SUBMISSION / OBSERVATION TO AN COIMISIÚN PLEANÁLA

Re: Crumhach Wind Farm, Co. Sligo

Case Reference: PAX21.324561

Submitted by: John Nugent

Figure A1. Combined excerpt from the applicant's submitted Sheets 3/5 and 4/5, annotated to identify my house / residential curtilage and nearby turbines T8, T10 and T13.

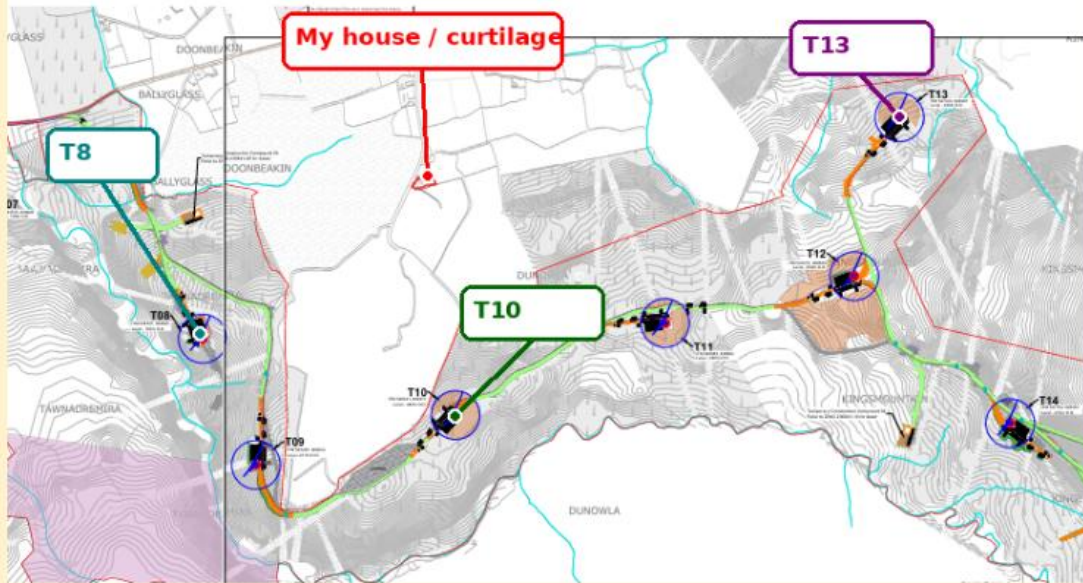
I make the distance of T10 to my curtilage as 715 metres.

This map is a combination of sheets 4/5 and 3/5 from the applicants own planning drawing submitted in their application. Interestingly I couldn't find a map with my house and all relevant turbines submitted so this is the best I can do. It shows the impact the turbines will have on 3 sides of my property

My house / curtilage is the small red outline north of T10 and west of T13.

The map is included to illustrate the curtilage-based 720 m setback issue. I request that An Coimisiún Pleanála independently verify the shortest distance between T10 and the nearest point of the residential curtilage using the application GIS data.
